TIB-OLY023-00

TECHNICAL INFORMATION BULLETIN

Olympian Gas powered GM8.1 Engines

SUBJECT: Approaching Low Oil Pressure warnings and
Low Oil Pressure shutdowns.

Figure 1 – Correct 62k ohm resistor R131

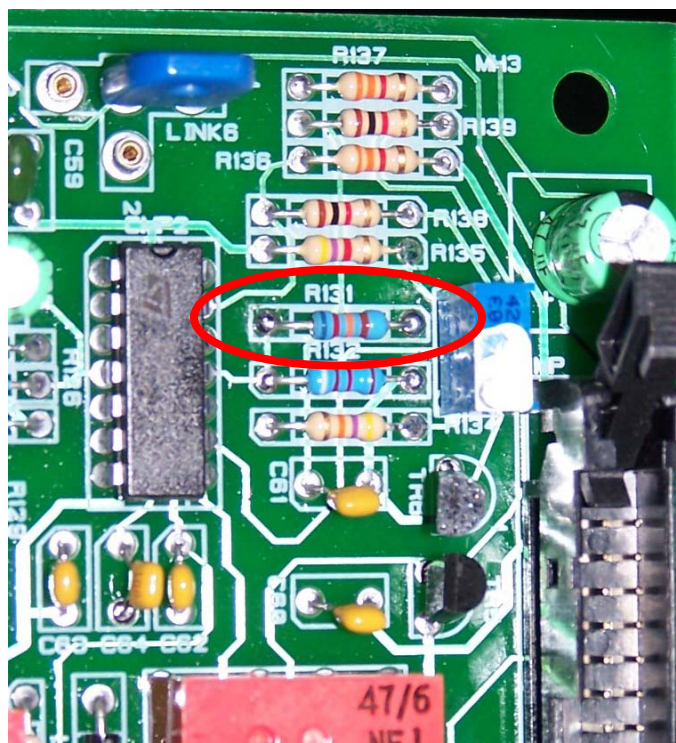
Some of the 4001E expansion boards for the GM product have been fitted with an incorrect resistor that allows nuisance approaching low oil pressure alarms. Resistor R131 should be 62k ohms but may be 39k ohms. The correct (62k ohm) resistor can be identified by the color codes: blue (6), red (2), orange (00) with an additional tolerance color band, or blue (6), red (2), black (0), red (00) with an additional tolerance color band.

The part number of the correct PCB board is 650-432. However some of the newer boards still have the old part number (650-217) and you will need to verify that the correct resistor has been fitted. See figure 1.
